Service Bulletin

S.B. No: 179

Title: INSPECTION OF TAILPLANE ATTACHMENT BRACKETS

CHANGES INCORPORATED BY THIS ISSUE 3:

FIGURE 2

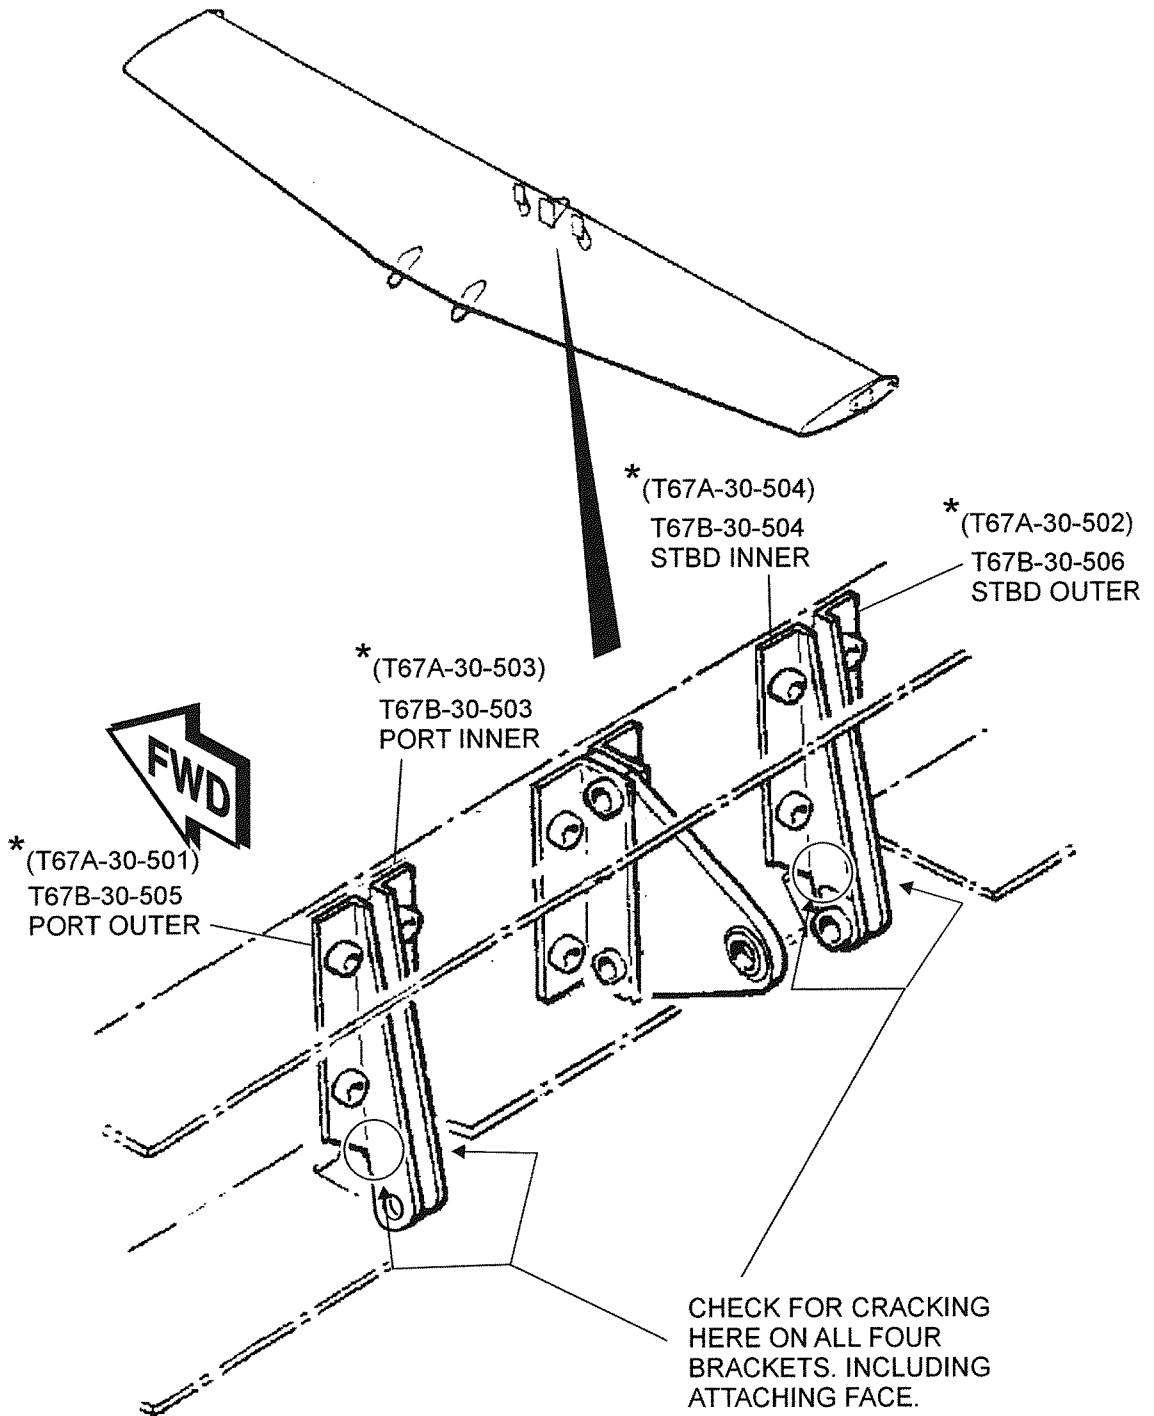
NOTE 1 Prior to torquing main bolts, ensure there is either no gap or a gap of up to a maximum of .010" (.25mm) between fittings. If a gap greater than .010" (.25mm) does exist after taking up slack then it is permissible to fit washers as follows:

Washer/s of thicknesses 0.016" (.4mm) (SAL Stores Code 126-23-750) or 0.018" (.46mm) (SAL Stores Code 126-23-754) or 0.032" (.81mm) (SAL Stores Code 126-23-747). Thinning of 0.032" is acceptable providing faces of washer remain parallel. Re-protect modified face, use Duralac.

NOTE 2 Ensure that the brackets are not forced apart when fitted.

FIGURE 1

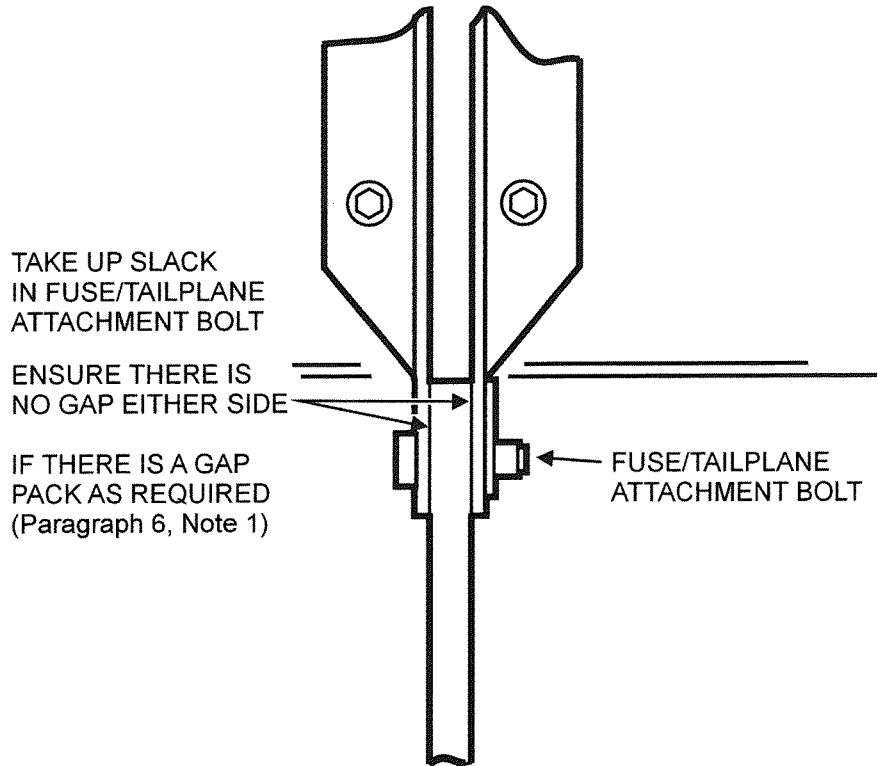
1. Check master switch, ignition switch and fuel are OFF. Disconnect external power and hangar aircraft, if required.
2. Remove tailplane and gain access to aft tailplane mounting brackets and remove from tailplane main spar. Ref. Figure 1.

4. Perform dye penetrant (or similar) NDT crack detection on brackets and examine, paying particular attention to the region illustrated in Figure 1.
5. Should any crack be discovered, then all four tailplane-mounted brackets from the subject aircraft shall be returned to SAL and replaced with new items.
